Partial Correction of Interim Report (revision) concerning Seismic Safety Evaluation of Unit 2 in Fukushima Daini Nuclear Power Station

Figure 1 Image of Analysis Model

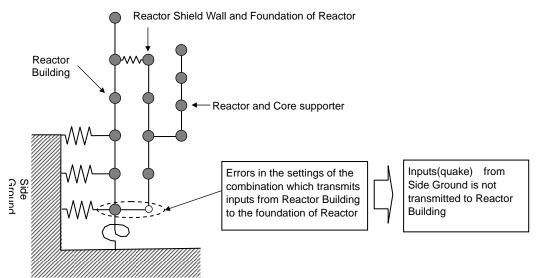
Later, during our verification of the analysis result in the process of evaluating seismic safety, we found some errors in the analysis model used for the report already submitted.

The method to verify the reasonableness of the analysis result was unclear at the time of conducting the analysis, however, the verification process was reviewed after the submission of the interim report. This time the errors in the analysis model were found in the reviewed verification process of the reasonableness, therefore similar errors will be avoided in the future.

We will make sure to conduct examination based on the reviewed verification method of the analysis results.

We will amend the computer program so that if there are similar errors in the analysis model the calculation is stopped.
